**Wisconsin Electric** POWER COMPANY  
231 W. MICHIGAN, P.O. BOX 2046, MILWAUKEE, WI 53201

DOCKET NO. 50-266  
POINT BEACH NUCLEAR PLANT, UNIT 1  
STEAM GENERATOR REPLACEMENT

WISCONSIN ELECTRIC POWER COMPANY RESPONSE  
TO NRC STAFF REQUEST FOR ADDITIONAL INFORMATION  
POINT BEACH UNIT 1 STEAM GENERATOR REPLACEMENT

STEAM GENERATOR REPLACEMENT OR RESLEEVEVING  
DIFFERENCE IN  
DISCOUNTED ACCUMULATED REVENUE REQUIREMENTS

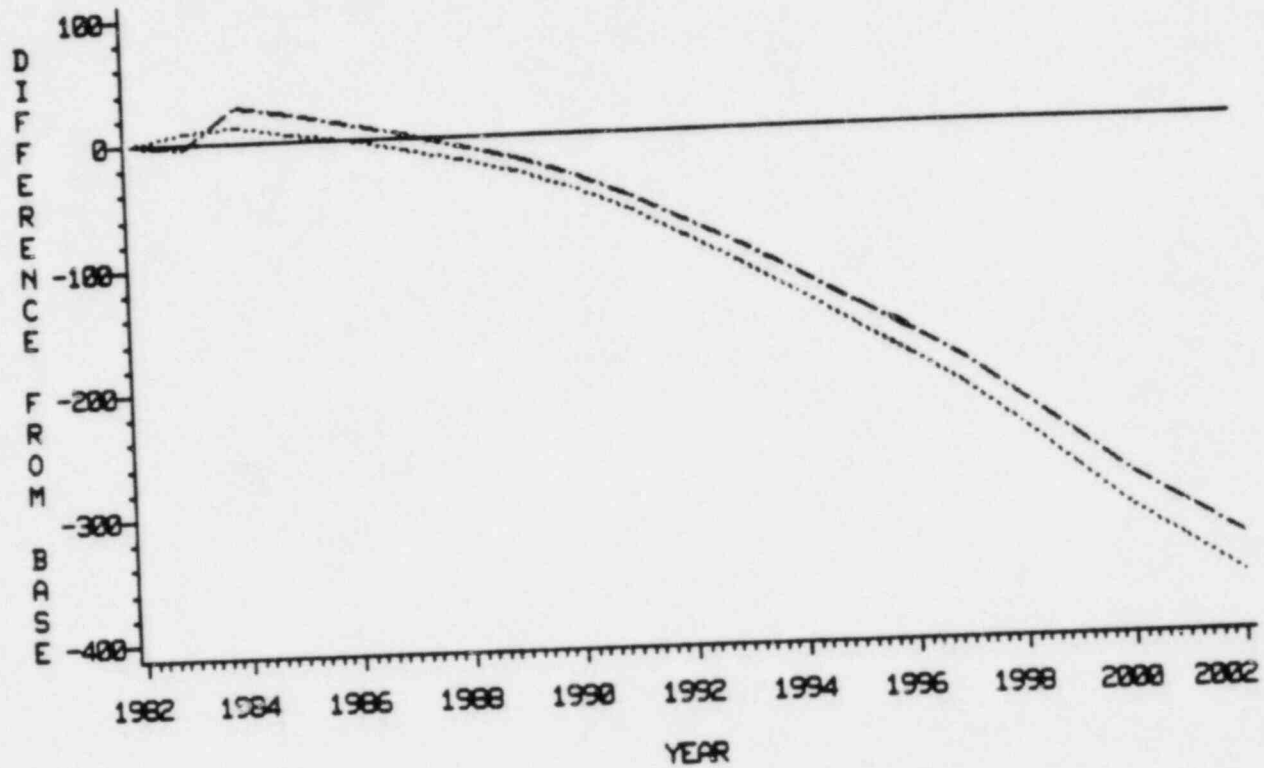
Provide a present worth comparison of accumulated annual charges, including annual production costs over the life of the plant, for the following alternatives:

1. The proposed steam generator repair plan.
2. Replacement of Point Beach 1 by alternative sources, purchases and/or generation.
3. Steam generator repairs, such as initial resleeving and periodical plugging, coupled with reduced output as necessary.

Provide cost estimates and assumptions used for the cost comparisons such as cost additions (including cost of required new generation and transmission

facilities), fixed charge rate, discount rate, inflation, nuclear fuel cost, purchase power cost, nuclear O&M cost, alternative fuel cost, alternative's O&M cost, and decommissioning costs.

Mr. Abdoo's testimony, prepared for the Public Service Commission of Wisconsin, provides the revenue requirements on a year-by-year basis or the accumulated future revenue requirements for a number of years discounted to the present for the proposed steam generator replacement plan as compared to the option of continued operation of Unit 1 as is. The period of the analysis is from 1983-2003. The differences in revenue requirements between the two options are provided on pages 8 and 10 of the attachment to Mr. Abdoo's testimony. The difference in discounted accumulated revenue requirements between the two options is provided on pages 9 and 11 of the attachment; estimated discount rates and inflation rates for the analysis are provided on page 4 of the attachment; nuclear and alternative fuel costs are provided on page 5 of the attachment; and production costs for nuclear and non-nuclear generated energy are provided on page 6 of the attachment.
